DEVELOPMENT REVIEW COMMITTEE –*September 15, 2020*
CONDITIONS OF APPROVAL

<u>101 Broadway</u>
Architecture and Site Application S-20-003

Requesting approval for demolition of an existing single-family residence and construction of a new single-family residence located in the Broadway Historic District on property zoned R-1D:LHP. APN 510-45-041.

Scale :
Date :
Sheet
A-1

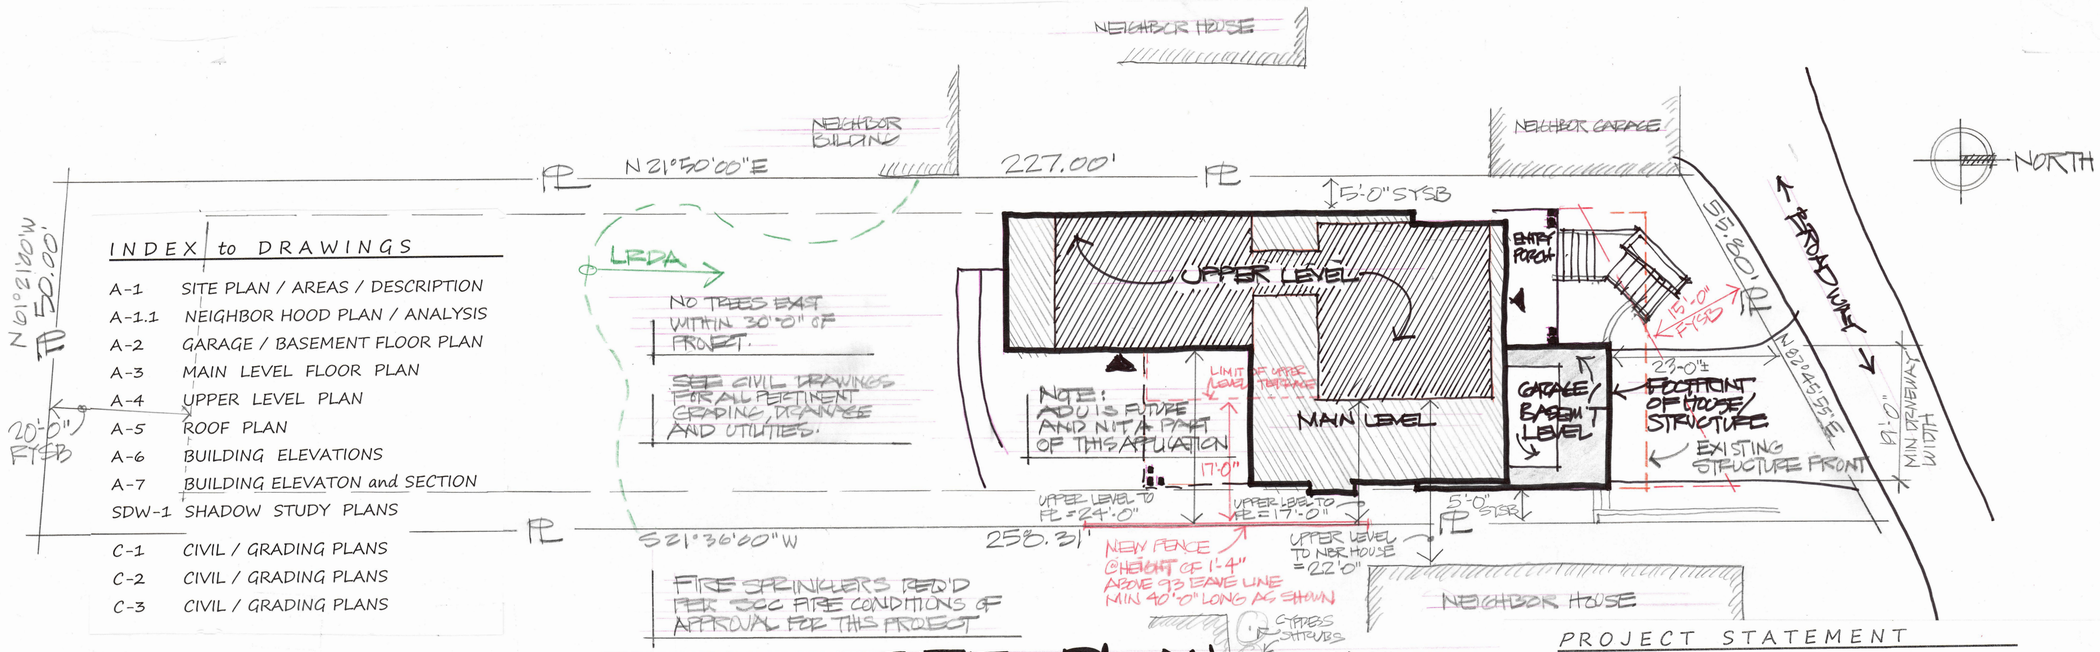
3. SIDING: The new residence shall utilize wood channel lap siding as recommended by the Historic Preservation Committee.
4. <u>SIDE YARD SCREENING: A fence shall be constructed along the east side property line adjacent to the neighbor's patio, with a height not less than 1.33 feet above the neighbor's eave line shall be constructed. This fence shall extend a length of not less than 40 feet centered on the neighbor's patio, in substantial conformance to that shown in Exhibit A attached hereto.</u>

5. <u>UPPER-LEVEL TERRACE: The extent of the upper level terrace adjacent to the master bedroom shall be reduced to be 17 feet away from the east side property line, in substantial conformance to that shown in Exhibit A attached hereto.</u>

A-7

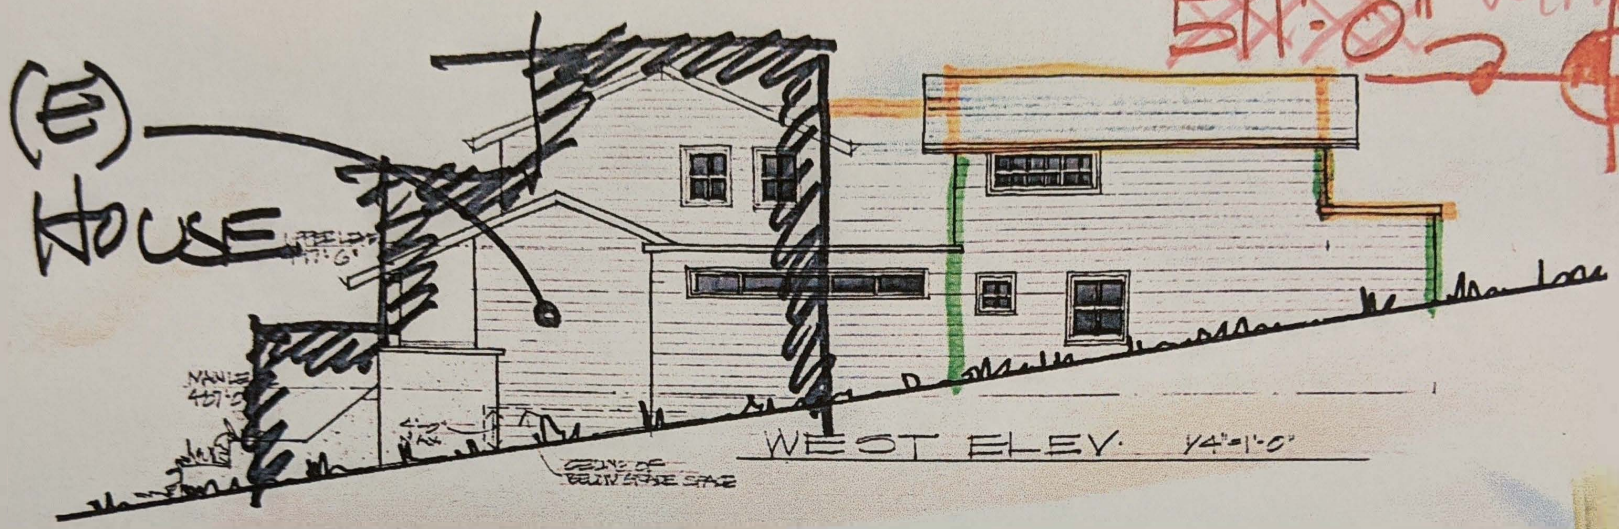
6. <u>ROOF RIDGE: The roof ridge above the master bedroom and master bathroom orientated north-to-south shall be reduced in height not less than six (6) inches to an elevation not to exceed 510. Feet, in substantial conformance to that shown in Exhibit B attached hereto.</u>

9-11-20 510'-6" PER PRIOR AGREEMENT WITH 107.

~~511'-0"~~
